CITY OF ALBUQUERQUE

RE: Lot 2 Block 2 Unit 27 SAD 228
5504 Valiente Rd NW
Volcano Cliffs Subdivision
Grading and Drainage Plan

Engineers Stamp Date 3/29/20 (C11D006)

GRADING AND DRAINAGE PLAN

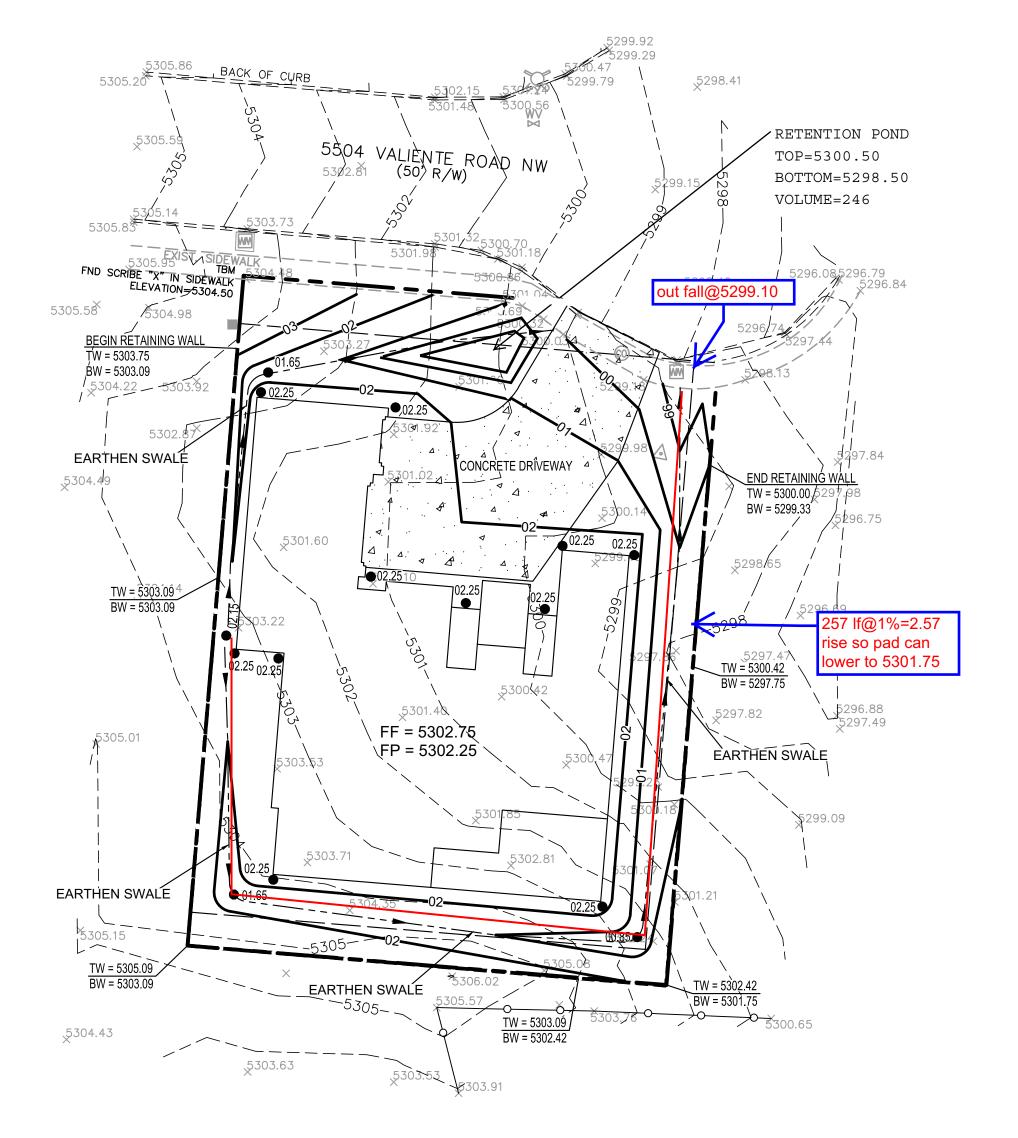
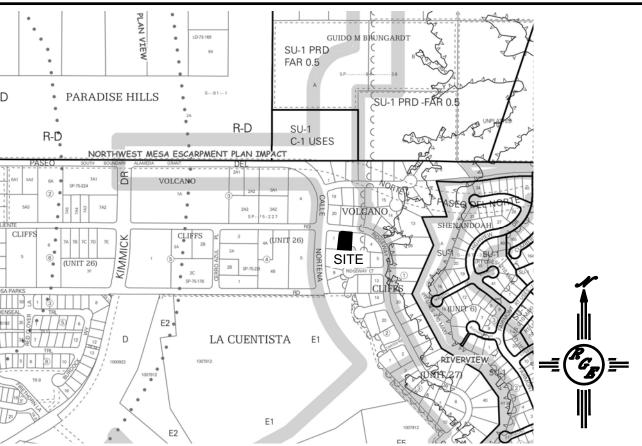
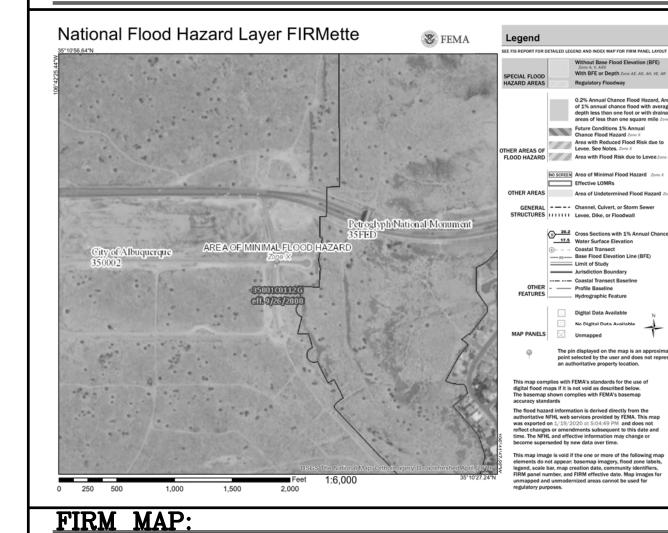
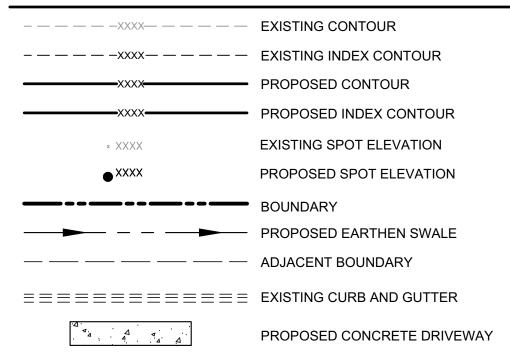
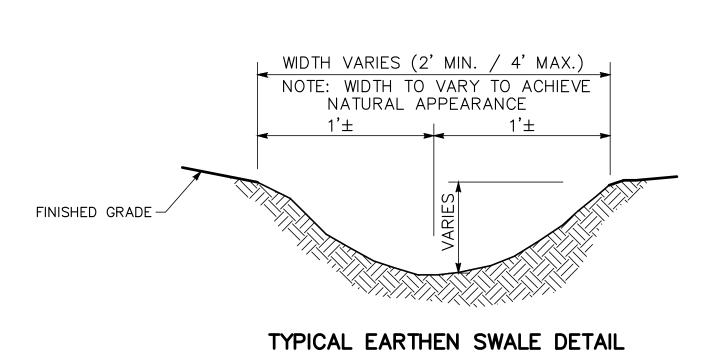
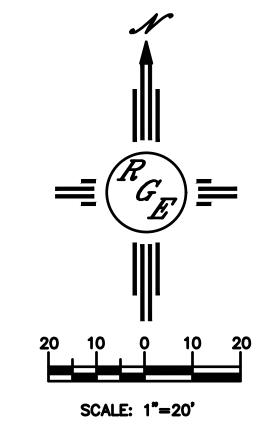
Based upon the information provided in your submittal received 429/2020, this plan is approved for Grading Permit.

Prior to Building permit approval a Pad Certification will be required, provided by the Engineer or a registered Land Surveyor.

Advise the owner contractor not to use dirt as a ramp to climb the curb, use lumber or crusher fines for this purpose.

Reiterate to the Owner/Contractor that a separate permit for a garden/retaining wall must be obtained with the approved G&D plan and Pad Certification. Also, if a swimming pool is to be placed the grading and drainage plan will change and will need to be resubmitted.

Prior to Certificate of Occupancy release, Engineer Certification per the DPM checklist is required.
